RE: Response to Request for
Culvert Design Changes
Natomas Trail Mtn. Mine
ACT/015/009
Emery County, Utah

RE: Culvert Design Changes (Proposed)

NATOMAS TRAIL MOUNTAIN
FIGURE 7-13a.
CULVERT DETAILS

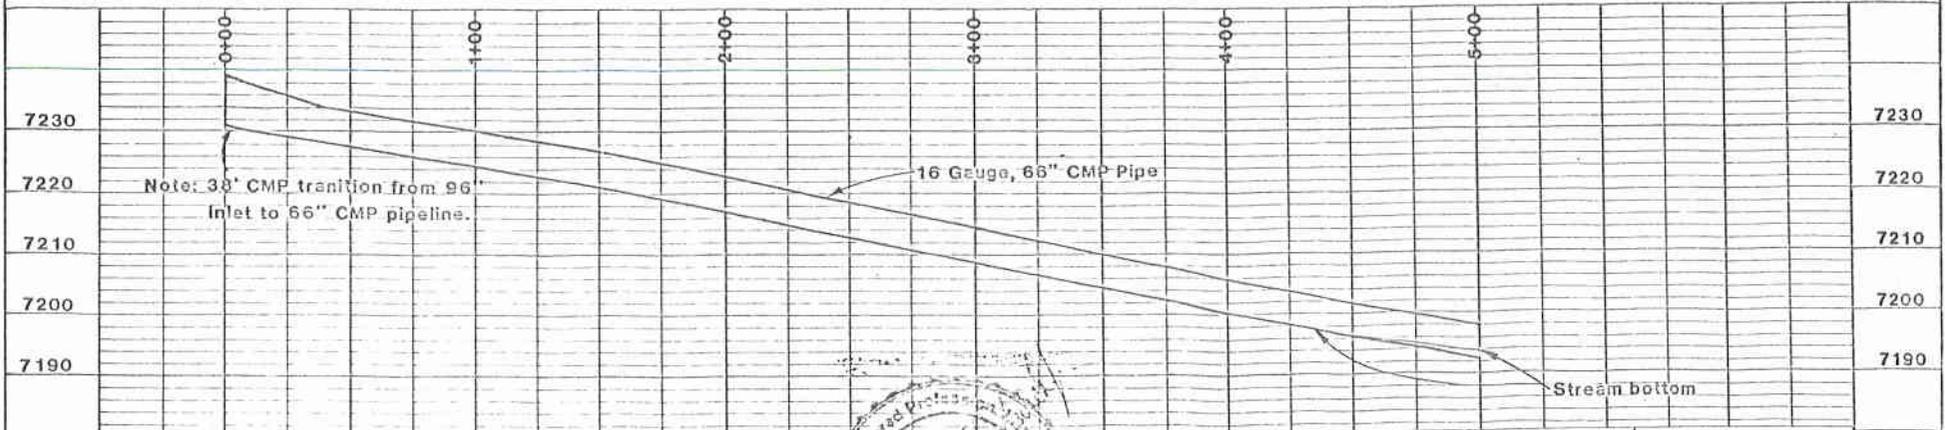
1. It is our understanding that the alignment change will constitute a minor extension of the primary discharge pipe which will connect with the 66-inch culvert.
2. The body of your latest letter states that only one bend will be eliminated from the culvert. However, the accompanying design drawing suggests that two bends will be eliminated or straightened (at Stations 4+80 and 6+30).
3. The Division considers the request for approval to construct a temporary inlet culvert acceptable with the following conditions:
 - A. All previous concerns as outlined in the previous December 7, 1981 approval must be met.

- B. The temporary inlet must be adequately protected from erosion and channel scour which may result during peak spring runoff flow conditions.
- C. The applicant must submit a general design drawing(s) depicting the type of temporary trash rack and inlet erosional control device(s) to be implemented.
- D. The final permanent inlet structure must be constructed during low flow conditions. This time frame also applies to the possible future extension of the 66-inch culvert not yet decided upon by the operator, nor approved by this Division.

looks like 2 bends eliminated
